URA RESOLUTION NO. 327

A RESOLUTION OF THE CITY OF WILSONVILLE URBAN RENEWAL AGENCY AUTHORIZING THE CITY MANAGER TO EXECUTE THE SECOND AMENDMENT TO CONSTRUCTION CONTRACT WITH MOORE EXCAVATION, INC. FOR THE 5TH STREET / KINSMAN ROAD EXTENSION PROJECT.

**CITY OF WILSONVILLE
SECOND AMENDMENT TO CONSTRUCTION CONTRACT**

Exhibit A - Change Order #02
Pay Item Adjustment

DATE:	11/11/2022
PROJECT:	ADJUST SCOPE OF PGE UNDERGROUND UTILITY WORK
DRAWN BY:	ADJUST SCOPE OF PGE UNDERGROUND UTILITY WORK
CHECKED BY:	ADJUST SCOPE OF PGE UNDERGROUND UTILITY WORK
SCALE:	AS SHOWN

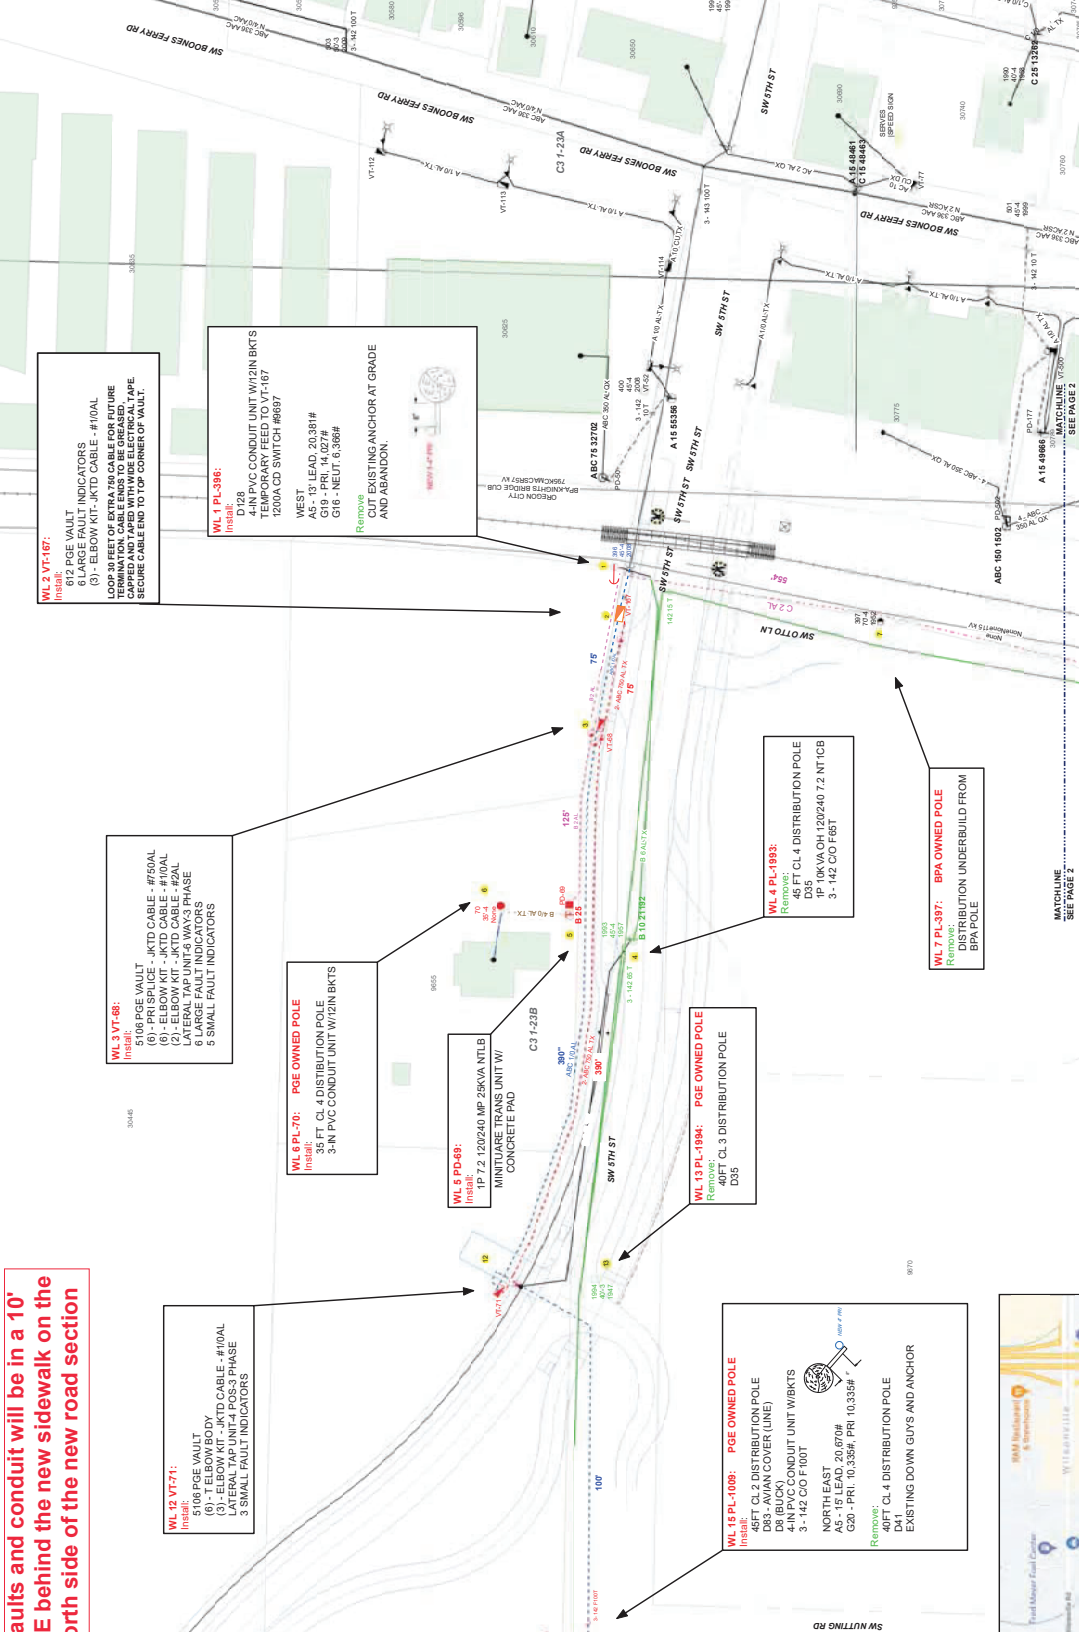
Adjust Scope of PGE Underground Utility Work – Upon start of project construction, PGE required the City to make numerous changes to the underground electrical design that would significantly increase the amount of PGE utility infrastructure to be installed as part of the project at the City’s expense. PGE claimed that the City never received approved PGE plans for the underground electrical work prior to construction bid and the changes were necessary to comply with current PGE requirements.

After negotiation between the City and PGE, it was determined the City is only responsible for undergrounding existing overhead electrical infrastructure, not expansion of PGE's facilities. Based on this determination, the scope of underground electrical work to be installed as part of the project at the City's expense was adjusted accordingly. The resulting PGE design changes are included on pages 1-3 of Exhibit C. The underground electrical design change results in reduced estimated quantities of 2", 4", and 6" PVC pipe (Pay Items 45, 46, and 47) and Old Castle Vaults (Pay Items 72, 73, and 74).

Add Standard Curb to PGE Vault 221

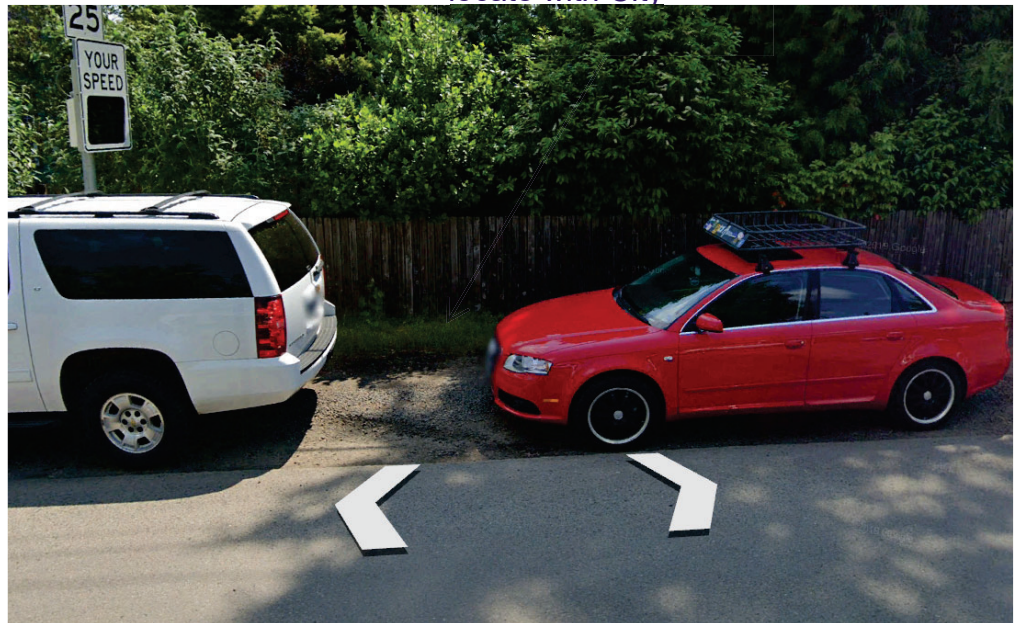
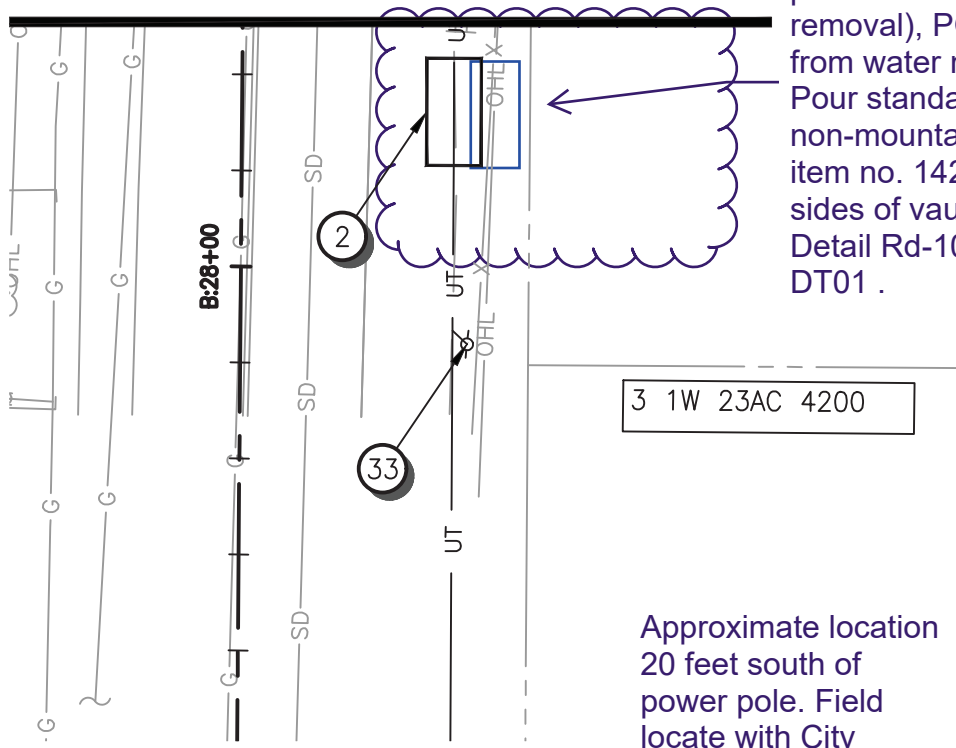
Add Standard Curb to PGE Vault 221 – During construction of the underground electrical infrastructure, PGE requested standard curb be installed along the outside edge of electrical vaults located within parking areas. PGE Vault 221 is located along an unimproved portion of Boones Ferry Road, south of 5th Street within an existing gravel area adjacent to the paved roadway. PGE vault lids are not structurally rated for traffic loading. As a result, PGE has requested standard curb be installed along the south, west, and north edges of PGE Vault 221 to prevent vehicles from driving over or parking on top of the vault lid. The design change is included on page 4 of Exhibit C. This design change results in increased estimated quantity of Pay Item 142 – Non-Mountable Median - Asphalt Streets.

Change Order Proposal (#018)
 Project: 5th Street/Kinsman Rd Extension
 Date: March 23, 2022

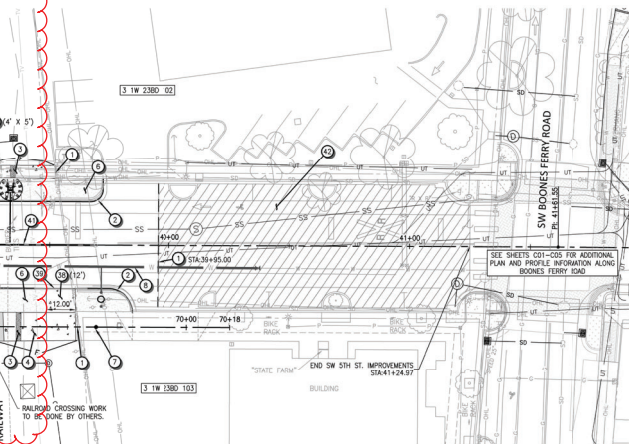
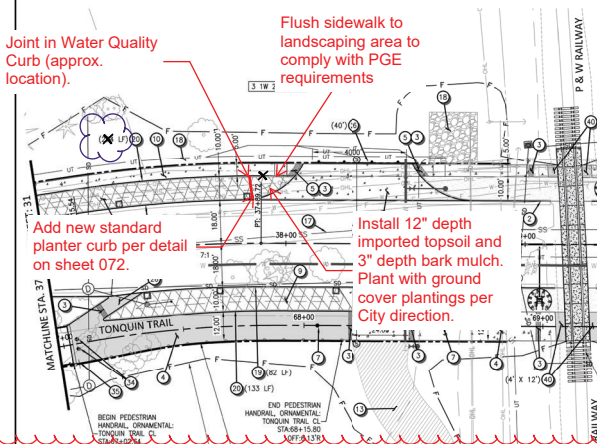
Prior to modification of the water quality facility for PGE Vault 68 as described above, a 12-foot long section of water quality curb had already been installed to the south of the vault. To accommodate the

conversion of the water quality facility to a standard landscape strip, this section of water quality curb needs to be removed.

REMOVE 12-FT SECTION OF CURB IN FRONT OF 612 PGE VAULT; POUR BACK STANDARD CURB; REQUIRED PER PGE SPEC FOR ACCESS TO VAULT (SHEET UT10)

Contractor provided timely notification to the City that the removal of the water quality curb results in added costs as documented by Change Order Request #018 (p. 8-11 – Exhibit C) and the City has determined that the work is an acceptable reimbursable project expense.

The Concrete Water Quality Curb Removal pay item shall include all cost for materials, equipment, and labor to remove and dispose of the identified section of water quality curb. This pay item will not be measured in the field and will be paid on a lump sum basis at the Contract price.

**SW 5TH ST TO SW KINSMAN RD EXTENSION
 5TH ST PLAN & PROFILE - ROADWAY
 PLAN AND PROFILE**

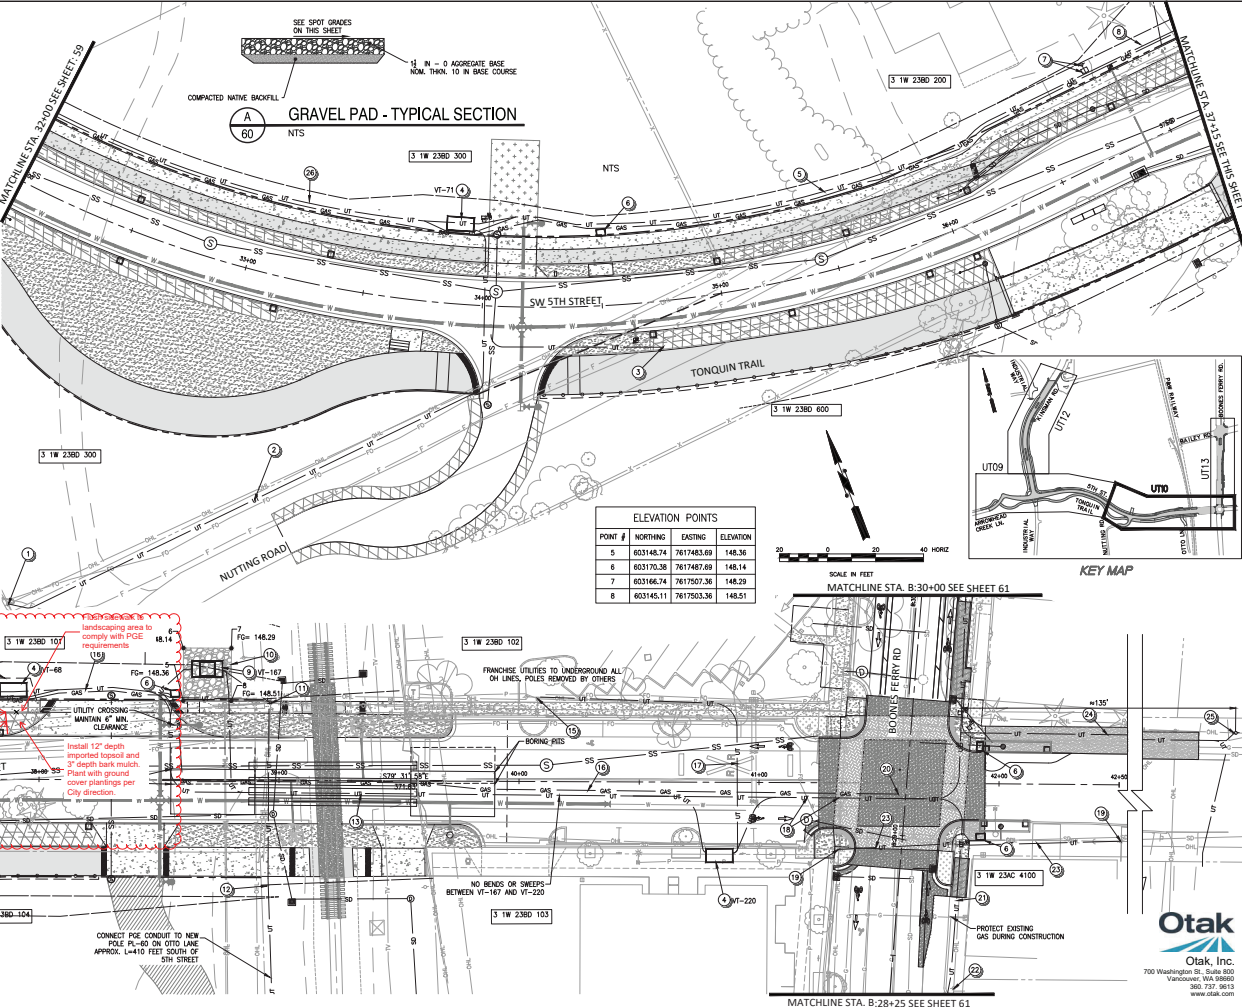
Modify Water Quality Facility for PGE Vault 68 – During construction of the underground electrical infrastructure, PGE requested that the water quality facility located south of PGE Vault 68 be replaced with a standard landscape strip to provide PGE required 10 feet worker safety clearance. The design engineer reviewed the request and confirmed the design change can be accommodated and is documented per Change Order Request #018 (p. 8-11 – Exhibit C). The design change results in a net decreased estimated quantity of Pay Item 148 – Concrete Water Quality Curb and increased estimated quantity of Pay item 141 – Non-Mountable Median - Concrete Street. It is assumed that the difference between backfill, excavation, soil, plantings and all other work not specifically identified in this Change Order No. 2 for the conversion of the water quality swale and the landscape planter strip is negligible for which no separate or additional measurement or payment will be made.

- 29 landscaping area to comply with PGE requirements
- 30 Joint in Water Quality curb (spec. location)
- 31 Add new standard number curb per detail on sheet 07.2

DP # 4196
 PROJECT # 2017-02-001
 UT10
 60 of 213

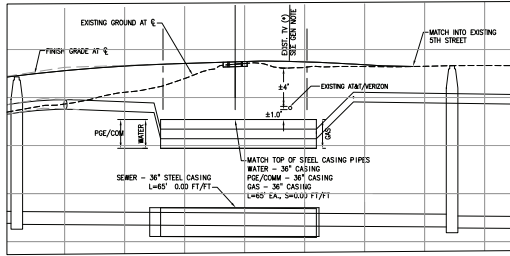
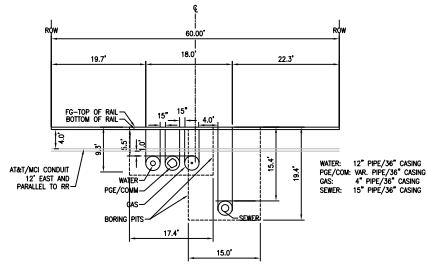
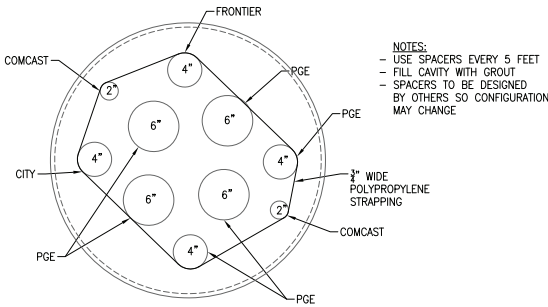
During bore installation of the 6” diameter casing pipe for the natural gas pipeline crossing beneath the railroad tracks, the Contractor was unable to complete the work after a number of attempts due to the presence of boulders. The Contractor determined that the small size of the casing pipe does not provide enough room to access and remove the conflicting portions of boulders. The Contractor proposes an upsized 36” diameter casing pipe to provide the needed space to remove conflicting boulders and complete installation of the needed casing pipe. In addition, the Contractor mistakenly installed a larger, 36” casing for the City water pipeline, rather than the 18” casing called for in the construction documents. The utility casing pipe design changes for the railroad crossing are included on pages 23-24 of Exhibit C.

Item	Description	Qty	Unit	Unit Price	Extension
Description of Change(s)					
Boulders were encountered while installing the 6" gas casing at the design depth of 7' ; This was not called out in the plans or geotech report and is a differing site condition; this COR reflects the standby time as a result, and the costs to upsize the casing to alleviate the boulder issue.					
Pricing					
Reject	Standby time	1.00	LS	\$ 17,118.04	\$ 17,118.04
Reject	Additional Work Upsize 6" Gas Casing to 36"	1.00	LS	\$ 17,824.20	\$ 17,824.20
Approve	CREDIT BI 55 6" Casing 7 FT Depth	1.00	LS	\$ (40,000.00)	\$ (40,000.00)
Approve	BI 57 36" Casing 7 FT Depth	1.00	LS	\$ 80,000.00	\$ 80,000.00
Reject	Bore Sub Additional DeMob and Mob	1.00	LS	\$ 12,800.00	\$ 12,800.00
Approve	City Share Gas Casing Relocation Work				\$20,000.00
	TOTAL				\$ 60,000.00
Terms, Conditions, and Scope Limits/Clarifications					
Additional contract days will be requested starting from the beginning of the delay on 10/18/2021 to the end of the delay when pricing is approved

The City and Contractor negotiated to determine responsibility for the additional incurred costs resulting from the Contractor’s attempts to install the 6” gas casing and installation of the larger utility casings. The City does receive some long term benefit to the larger casing installation and has some responsibility for sizing a casing large enough to effectively remove boulder conflicts. The City and

Contractor agree to share approximately half of the additional incurred costs as documented by Change Order Request #005 (p. 12-22 – Exhibit C). The City's share of costs are reflected by an increase in estimated quantity for Pay Item #57 – Installing 36 Inch Pipe Under Railroad, 7 FT Depth and a decrease in estimated quantity for Pay Item #55 – Installing 6 Inch Pipe Under Railroad , 7 FT Depth.

1. RR Crossing unforeseen change request. The City will accept the last settlement offer of paying the difference between the 6" casing and the 36" casing for the Gas casing (\$40,000) as well as paying 0.5 of the 6" bid item for all other extra work claimed (\$20,000).
2. Water Quality Curb reinforcing credit. The City will accept the last credit amount of \$7,000.00.

CHAIN LINK FENCE AND GATE

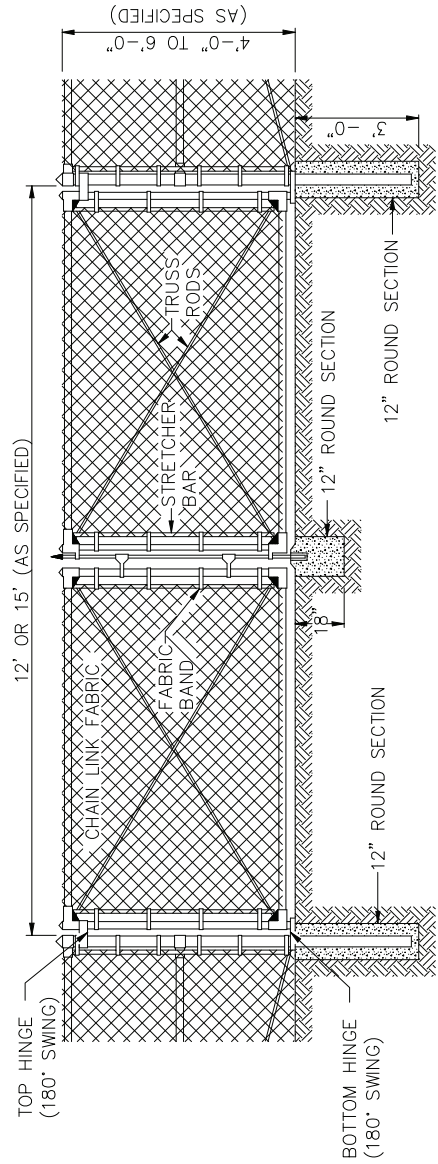
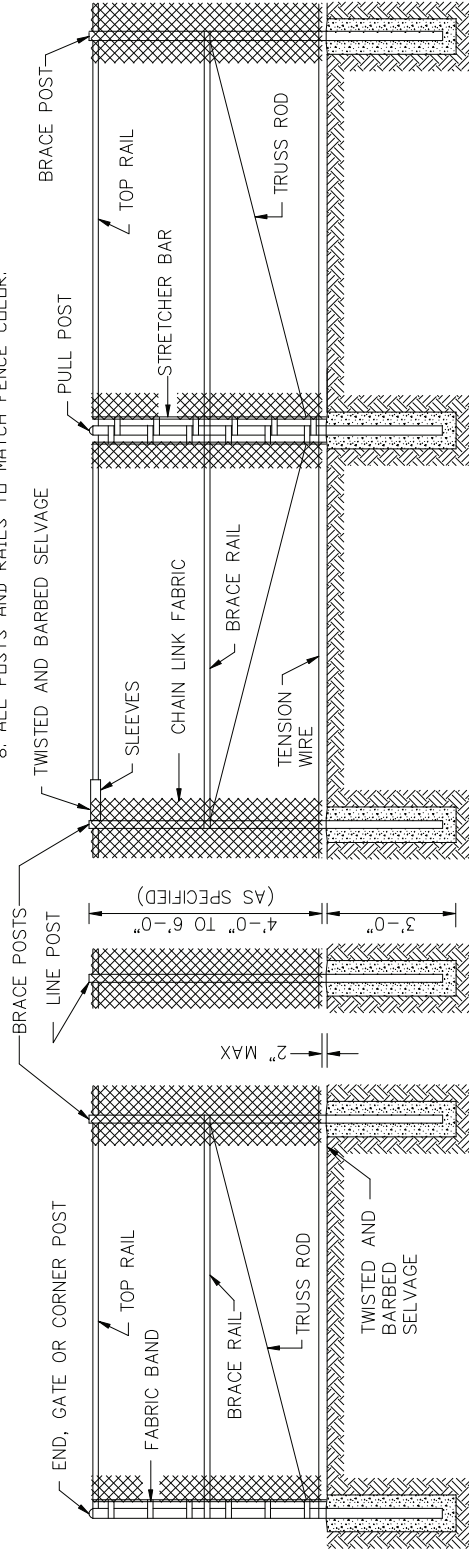
Contractor raised a safety concern with the design engineer regarding a potential fall hazard where the sidewalk is adjacent to the bridge wing wall. There is an elevation difference of up to 4 feet between the top of the bridge wing wall and the adjacent Coffee Lake Creek with no barrier provided between the sidewalk and bridge wing wall. The City and design engineer agreed with the Contractor's safety concern and proposes installation of a 4-foot high, black, vinyl coated, chain link fence for each wing wall on both the 5th Street Bridge and Kinsman Road Bridge as documented in RFI 080 (p. 29-32 of Exhibit C).

Sheet PP-03 Note 25 calls for a 31" height guard rail.

The Bridge Wing Wall Fence pay item shall include all costs for materials, equipment, and labor to construct the fencing as directed in RFI 080 (p. 29-32 of Exhibit C) and Section 01050 of the 2018 Oregon Standard Specifications for Construction. This pay item will not be measured in the field and will be paid on a lump sum basis at the Contract price.

The city would like to add chain link fence. Please provide a proposal for installing 4-foot high black chain link fence (CWS standard detail No. 792) for each bridge. The fence locations would be from the corner for the bridge railing along the back side of the wing walls at all four corners. Please follow OSHA standards and requirements. The tops of the poles should be situated as best as possible below the decorative bridge deck railing. Confirm field location and fit with city inspector prior to placing.
